VALUE ENGINEERING

KENTUCKY 121 – SECTION 1

GRAVES COUNTY

Project: NEW ROUTE KY 121 Team: # 2
 Location: MAYFIELD-AURORA SECT. 1 Date: 4-27-99

BRIDGE / OVERTLOW STRUCTURE

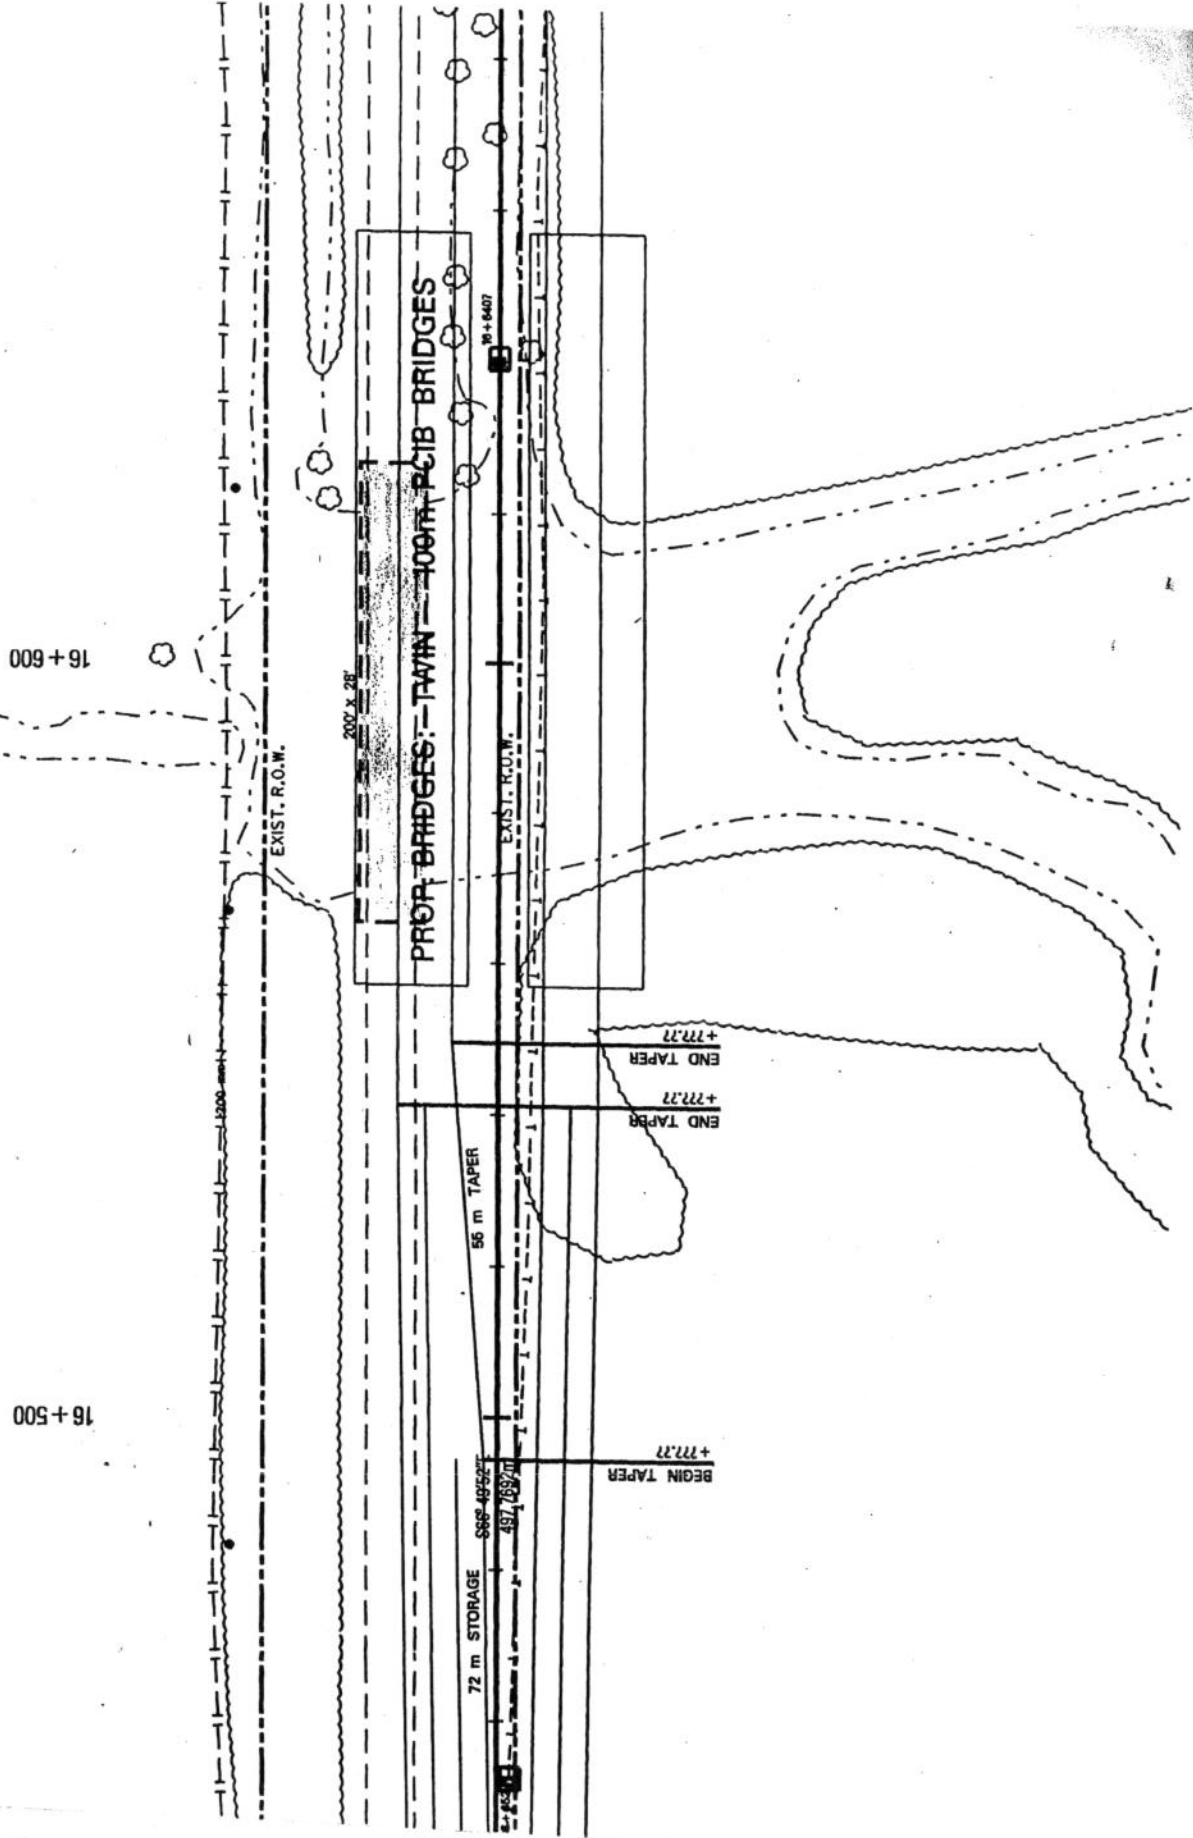
Exist. Length = 61 m
Cons. Prop. Length = 100 m
Why is overflow bridge longer than bridge over main channel?

Exist. Length = 40 m

Cons. Prop. Length = 44 m

Our Prop. Structure → 1.5 m x 6 m x 50 m
Single Barrel
Culvert

16+800

ELIMINATE 44M PCIB BRIDGE
REPLACE WITH 6000MMX 1500MM R.C.B.C (50.3 M LENGTH)

100M PCIB BRIDGE @ STA 16+560 WAS INCREASED FROM CURRENT BRIDGE SIZE BY ~~A~~ 40 M. DUE TO THE INCREASE CONVEYANCE AREA OF THIS LOCATION, WE RECOMMEND A ^{50.3M LONG} 6000MM X 1500MM R.C.B.C. @ STA 16+800 TO REPLACE 44M PCIB BRIDGE. THIS WILL REDUCE THE COST OF THE PROJECT BY \$771,600 PRESENT WORTH. THE CONSTRUCTION OF A 6000MM X 1500MM R.C.B.C. WILL BE CONSIDERABLY LESS CONSTRUCTION TIME THAN THE 44M PCIB BRIDGE.

PROP. BRIDGES:
TWIN - 44m RCIB BRIDGES

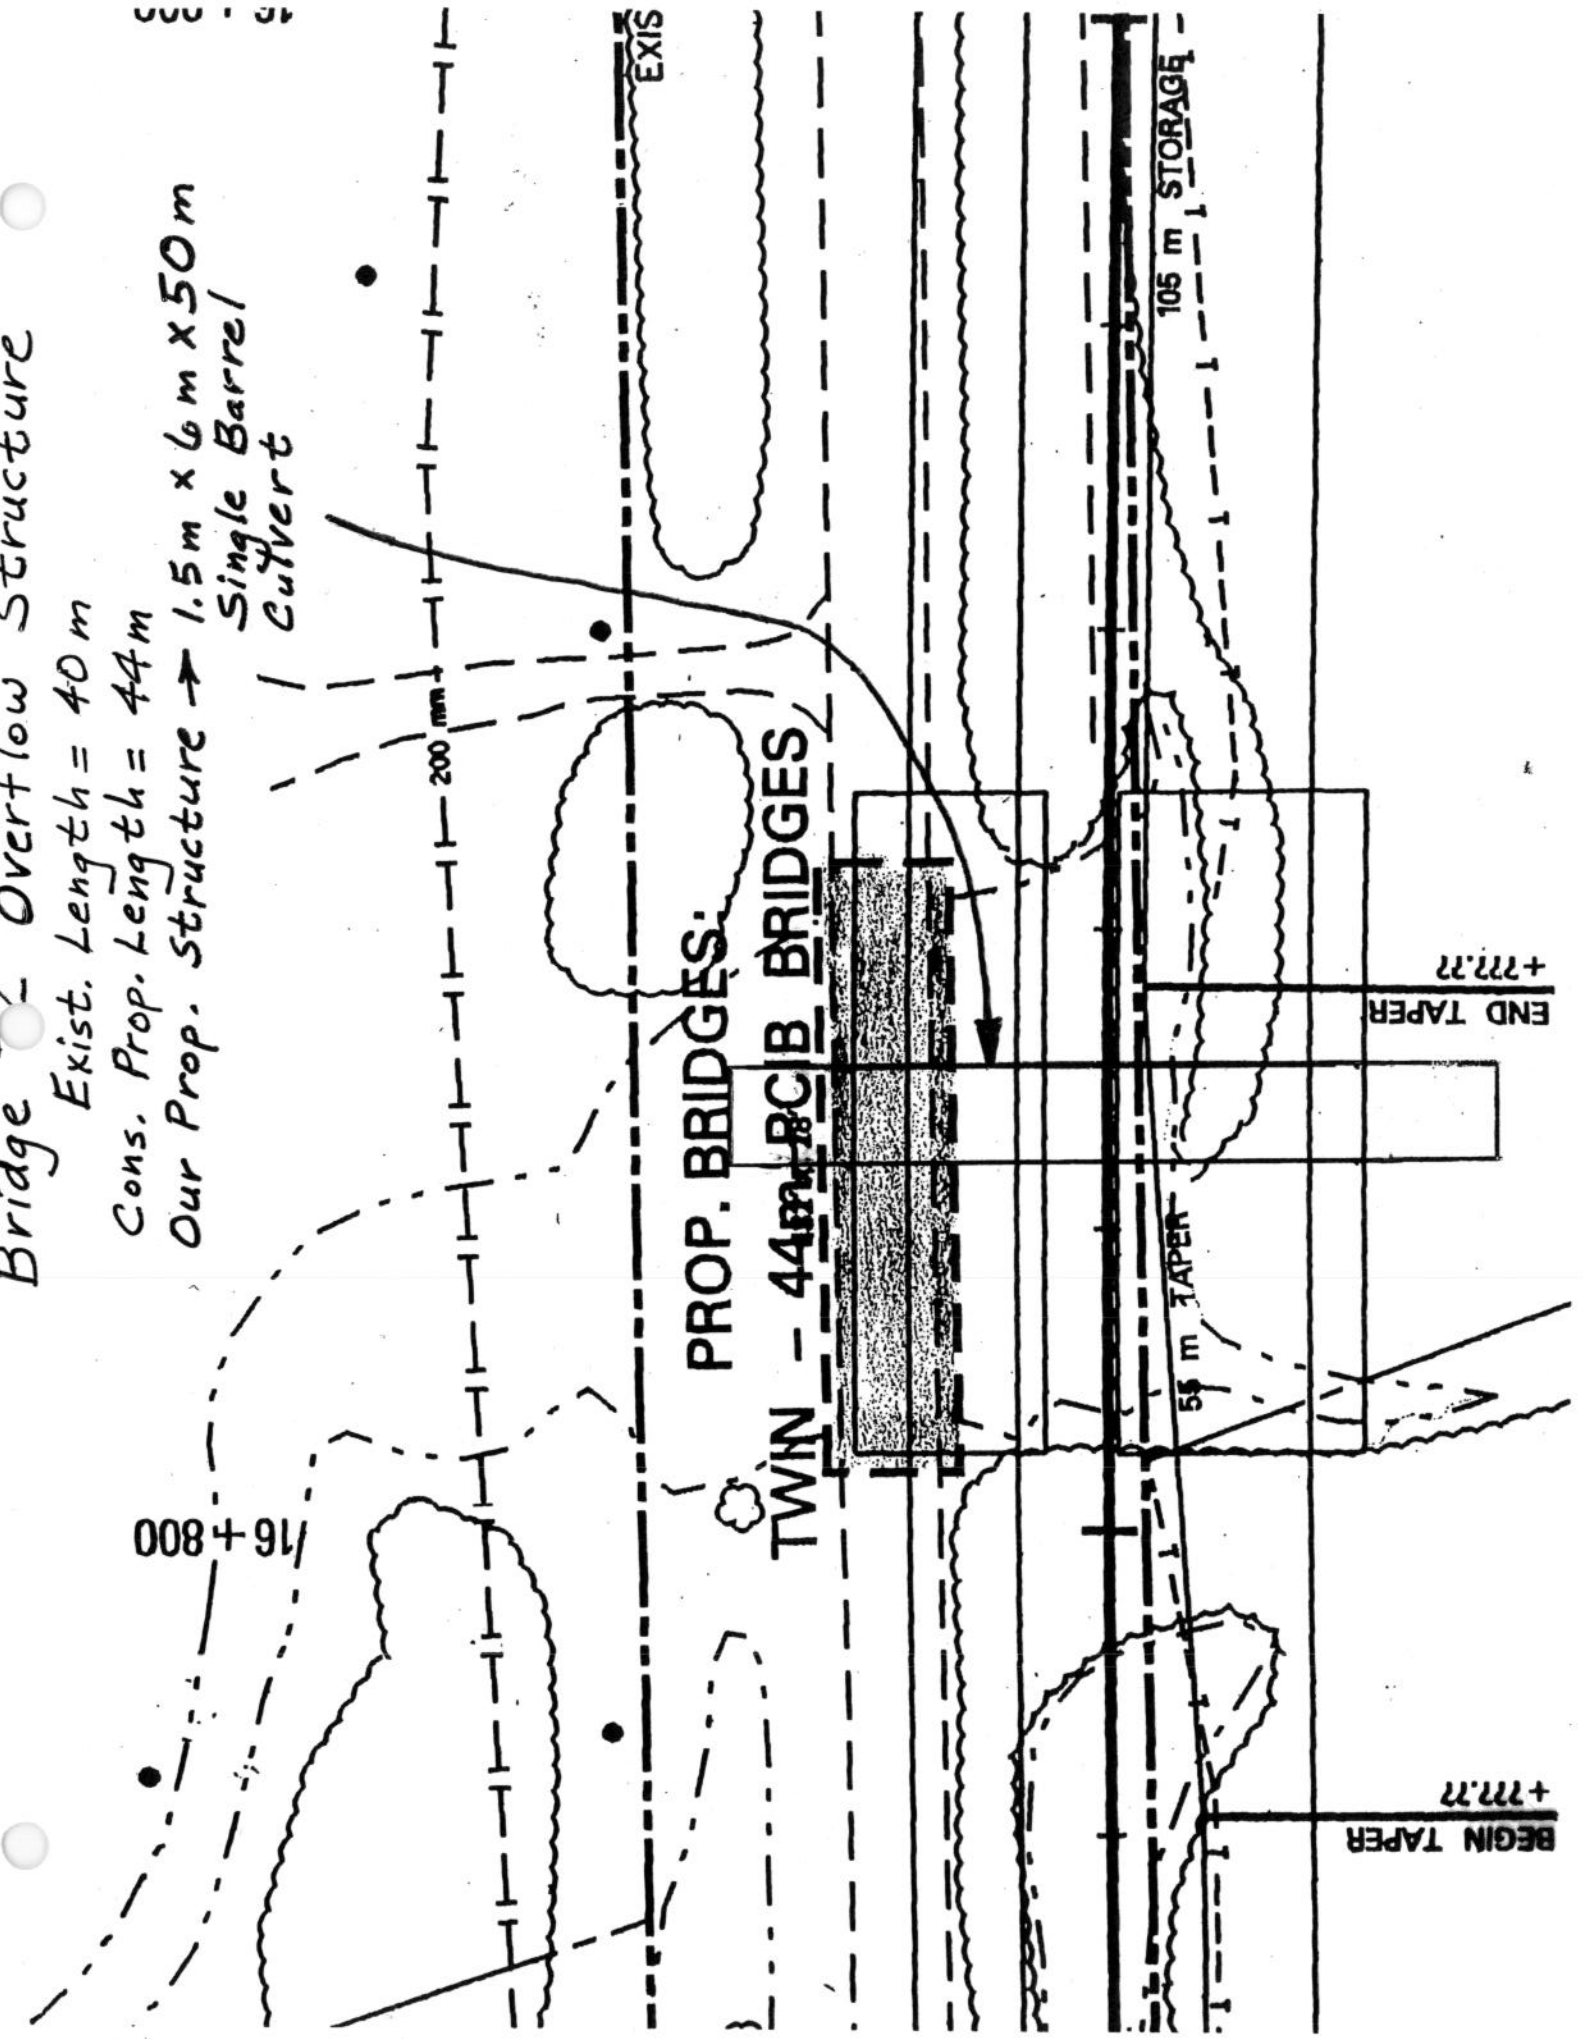
105 m STORAGE

55 m TAPER

ELIMINATE LEFT-TURN LANE INTO FIELD ENTRANCES. PROVIDE LEFT-TURN LANE ONLY FOR PUBLIC ACCESS.

THE LEFT-TURN MOVEMENTS INTO THE FIELD ENTRANCES WOULD BE MINIMAL. THIS SECTION WAS NOT FOUND TO HAVE A LEFT-TURN ACCIDENT HISTORY. THE COST BENEFIT RATIO OF THE ADDITIONAL TURN-LANE JUSTIFIES ELIMINATION

MAINLINE TYPICAL SECTION
DEPRESSED MEDIAN
(STA 15+856.680 TO STA 29+527.935)

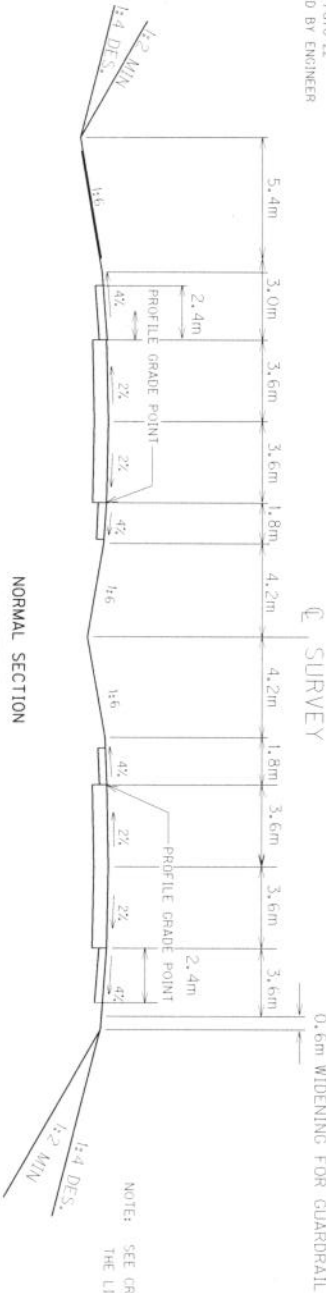
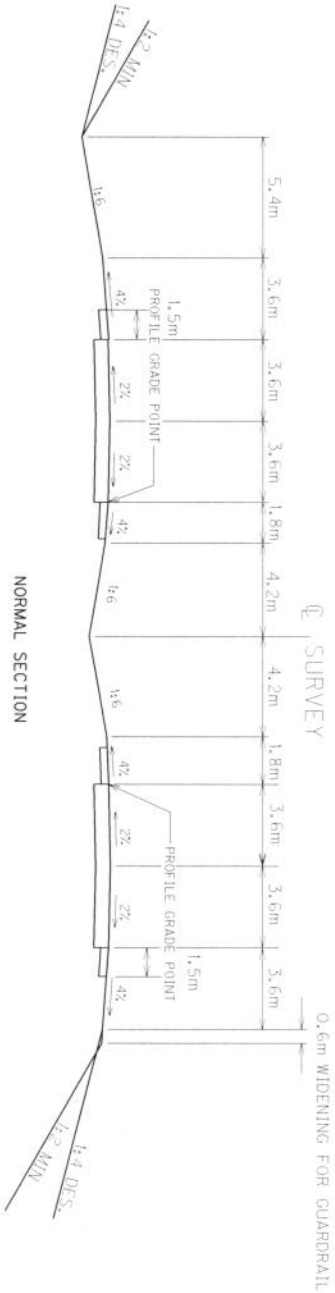
3.6 METER SHOULDERS (1.5 M PAVED AND 2.1 M
DENSE GRADE) WERE ORIGINALLY PROPOSED.

REDUCE THE SHOULDERS TO 3.0 METER (2.4 M PAVED
AND 0.6 M DENSE GRADE)

3.0 METER SHOULDERS STILL IN COMPLIANCE
WITH DESIGN MANUAL REQUIREMENTS.
